Request	-	Special Use Permit for Cultural Exhibit
Location	-	1600 Mott Avenue (parcel #1627991)
Applicant	-	Tom Waniewski Polish Cultural Center Advisory Board PO Box 291 Waterville, OH 43566
Owner	-	Polish Cultural Center Advisory Board PO Box 291 Waterville, OH 43566
Engineer	-	Troy Barman Lewandowski Engineers 234 N Erie Street Toledo, OH 43604

The applicant is requesting a Special Use Permit for a cultural exhibit at 1600 Mott Avenue. The site is ±2.99 acres and is zoned IL-Limited Industrial and POS-Parks and Open Space. The applicant is requesting a Zone Change for the parcel from its current mixed zoning designation to entirely POS-Parks and Open Space (companion case Z-12004-23). Surrounding land uses include Tribute Park, the Northwest Ohio Building & Construction Trades Council and I-280 to the north; Ravine Park II and single-family homes to the south; I-280 to the east; and Glass City Metropark and duplexes to the west. Per TMC 1104.0100 – *Use Table*, cultural exhibits require a Special Use Permit in the POS-Parks and Open Space zoning district.

SPECIAL USE PERMIT
TOLEDO CITY PLAN COMMISSION
REF: SUP-12003-23
DATE: February 8, 2024
TIME: 2:00 P.M.

BUILDING ELEVATIONS

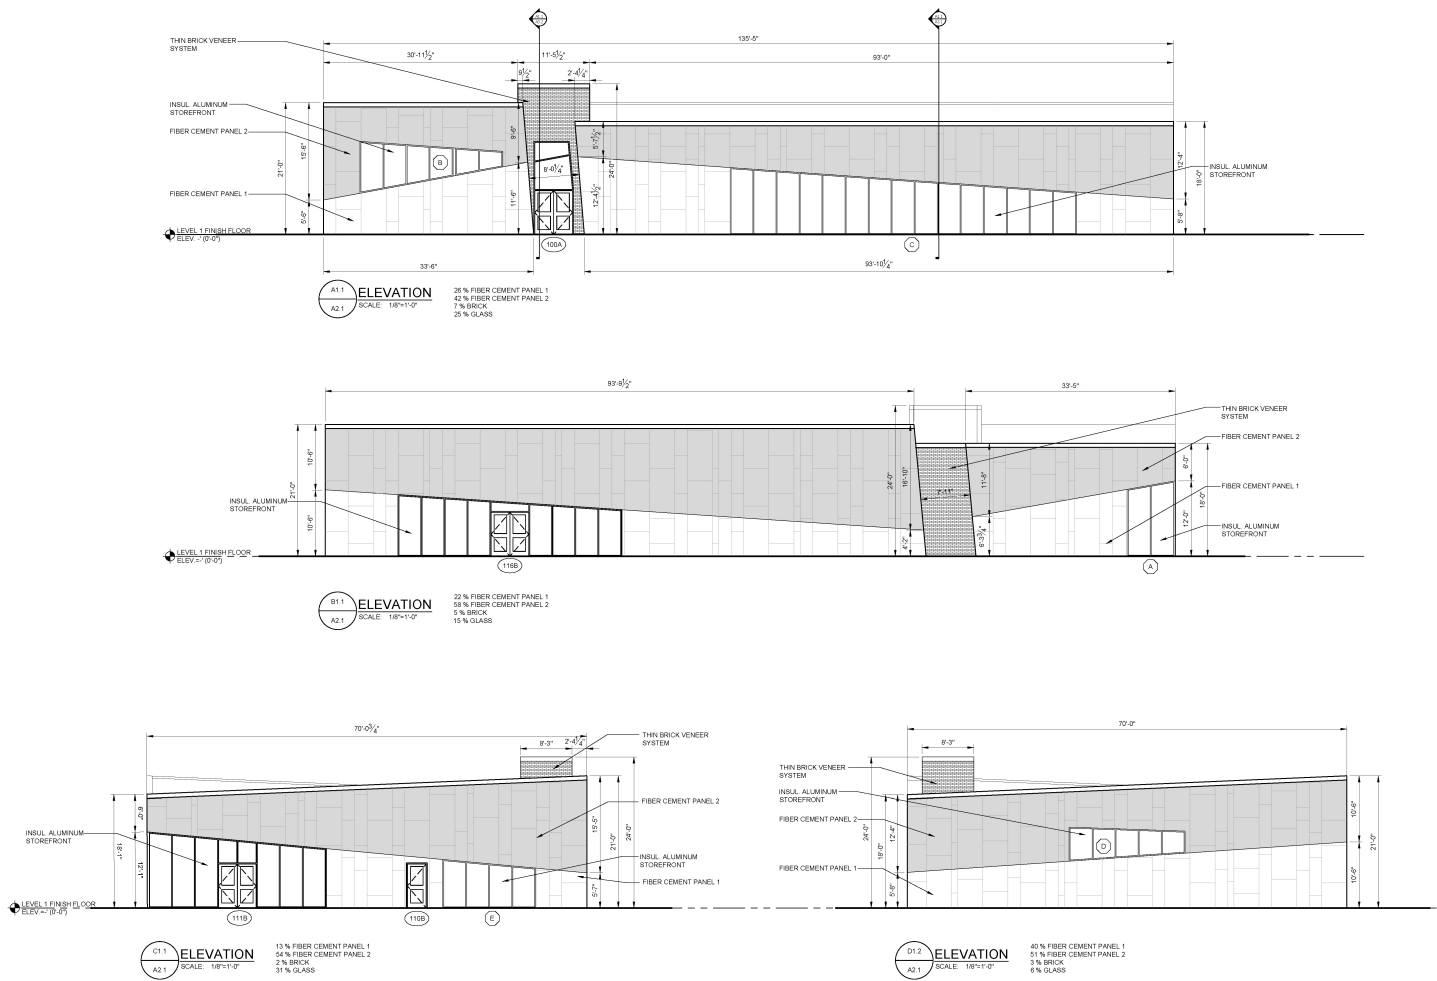
The proposed building elevations are comprised of two types of fiber cement panels, brick, and glass. The Planning Director has determined that the proposed fiber cement panels shall be classified as an "accent material" as per TMC§1109.0500 – *Building Façade Materials and Color*. In order to adhere to this code section, only up to 20% of each elevation may be comprised of accent materials. All four current elevations surpass this threshold significantly, with the minimum percentage of fiber cement panel depicted being 67% on the northeast elevation and the maximum percentage of fiber cement panel depicted being 91% on the southwest elevation.

Revised elevations must depict material types and percentages that are in conformance with TMC§1109.0500.

- 40. Building elevations shall be of quality materials as stated in TMC§1109.0500. **Not acceptable as depicted, as accent materials proposed surpass 20% of each elevation. Revised elevations must depict material types and percentages that are in conformance with TMC§1109.0500.**
